Access Compliance Report

Public Rights-of-Way

(Curb Ramps)

Intersection ID: 10023888	Main Street: COMMUNITY_HOUSE_RD	Cross Street: N/A	Location: NE
ADA ID: EA8053179FDA	Ramp Type: BlendTrans2	Initial Pass/Fail: Fail	Overall Compliance: No
Severity Score: 8.75			
Codes/Mitigation Info/Possible Solution		Field Measurements/Component Compliance

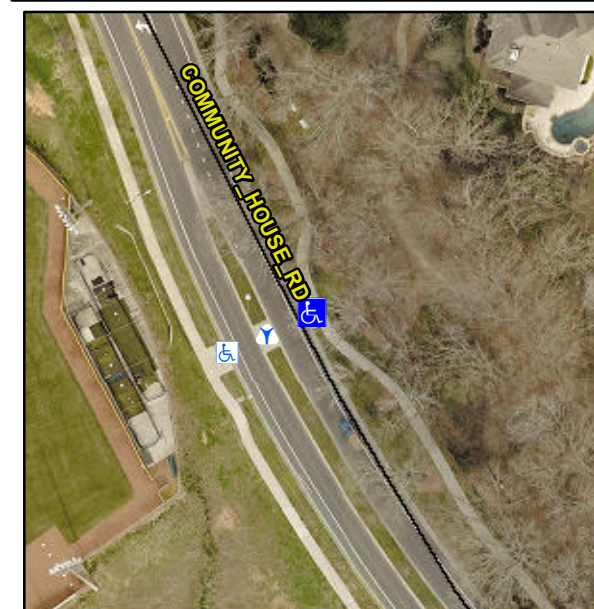
NO LNDG

R304.5.1

Compliance	Description	Data	Compliance	Description	Data
N/A	Ramp Length (in)	118.0	Yes	BlendTrans Slope (%)	2.7
No	Ramp Width (in)	47.0	Yes	BlendTrans XSlope (%)	2.0
N/A	Flare Type LT	N/A	N/A	Flare Type RT	N/A
N/A	Flare Slope LT (%)	N/A	N/A	Flare Slope RT (%)	N/A
N/A	Flare Traversable LT?	N/A	N/A	Flare Traversable RT?	N/A
N/A	Landing Length (in)	N/A	N/A	DWS Provided?	N/A
N/A	Landing Width (in)	N/A	N/A	DWS Contrast?	N/A
N/A	Landing Slope (%)	N/A	N/A	DWS Length (in)	N/A
N/A	Landing X Slope (%)	N/A	N/A	DWS Full Width?	N/A
N/A	Landing Curb? (Y/N)	N/A	N/A	DWS Offset (in)	N/A
N/A	Shared Landing?	N/A			
N/A	Gutter Ponding?	N/A	N/A	Gutter Slope (%)	N/A
N/A	Gutter Lip Ht (in)	N/A	N/A	Gutter X Slope (%)	N/A
N/A	Painted X Walk1?	No	N/A	Painted X Walk2?	N/A
	X Walk 1 Direction	To SW		X Walk 2 Direction	N/A
	X Walk 1 Width (in)	N/A		X Walk 2 Width (in)	N/A
	X Walk 1 Slope (%)	2.5		X Walk 2 Slope (%)	N/A
	X Walk 1 X Slope (%)	1.9		X Walk 2 X Slope (%)	N/A

Remove & Replace Curb Ramp With Two New Directional Ramps or Equivalent.
